# **FIRE SAFETY INSPECTION REPORT**

## **ETTADE JEANS LTD.**

**ACCORD**  
on Fire and Building Safety in Bangladesh

May 8, 2014

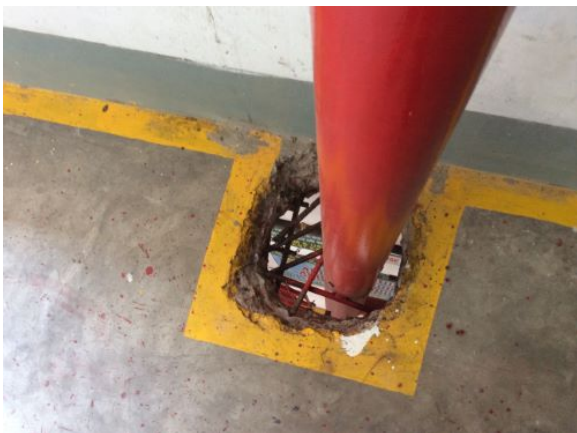
No.	Category	Finding	Recommendation	Remediation Timeframe
F-1	Fire Rated Construction	The exit stairs were not separated from work areas on each floor by fire-rated construction.	<p>Provide minimum 1.5-hr fire rated doors and seal all unprotected openings to separate the exit stairs from work areas and other building spaces on all floor levels. Ensure that the fire doors are self-closing and positive latching and that they are provided with fire exit (panic) hardware where serving production floors.</p> <p>If fire doors are required to be held open for functional reasons, provide automatic-closing devices tied to the fire alarm system.</p>	Within 3 months

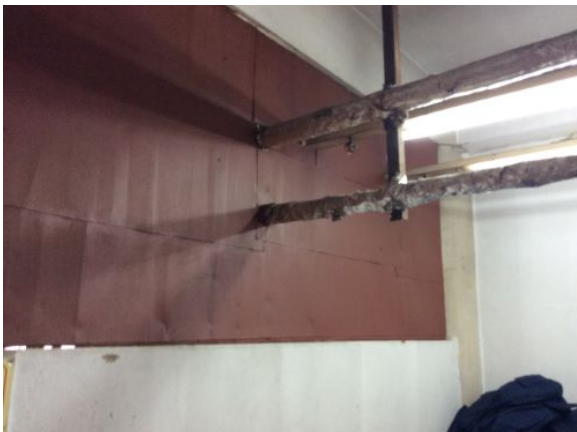
F-3	Fire Rated Construction	The boiler, generator and transformer rooms were not separated by fire-rated construction from the third floor, North and West exit stair discharges.	Separate the boiler, generator and transformer rooms by a minimum 2-hr fire-rated construction. Seal and protect all openings to maintain the required fire separations	Within 3 months
-----	-------------------------	---	---	-----------------

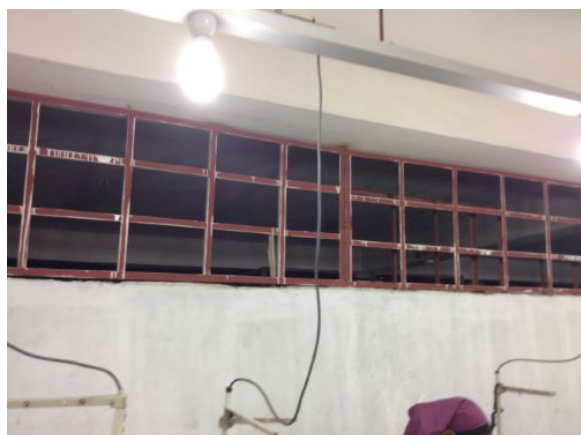
F-4	Fire Rated Construction	Areas used for combustible storage were not separated by fire-rated construction on all the floors except first, second and sixth floor.	Provide dedicated storage rooms separated by minimum 1-hr fire-rated construction.  Where separate storage rooms are not feasible, provide defined storage areas and limit the storage arrangement as follows: - Maximum height of 2.4m and maximum area of 23m <sup>2</sup> - If sprinkler protected: maximum height of 3.66m and maximum area of 93m <sup>2</sup>  Separate areas of unenclosed combustible storage by a minimum clear distance of 3m.	Within 3 months
-----	-------------------------	--	--	-----------------

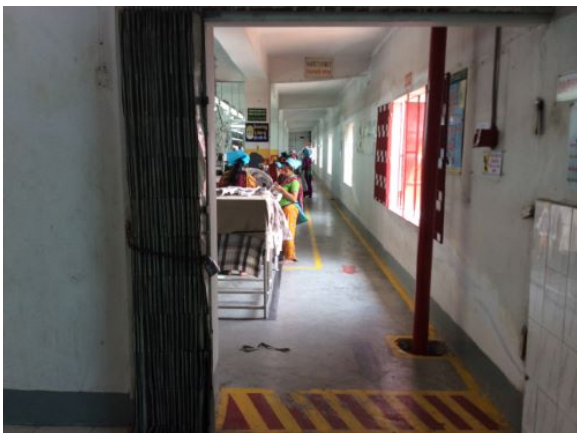
F-12	Egress	Collapsible gates and sliding doors were provided along egress routes, exit stairs, exit discharges and building exits.	Replace all gates / sliding doors along the means of egress with side-hinged, swinging egress doors.  If locks are required for security reasons, utilize special door locking features complying with NFPA 101.	Within 1 month
------	--------	---	--	----------------
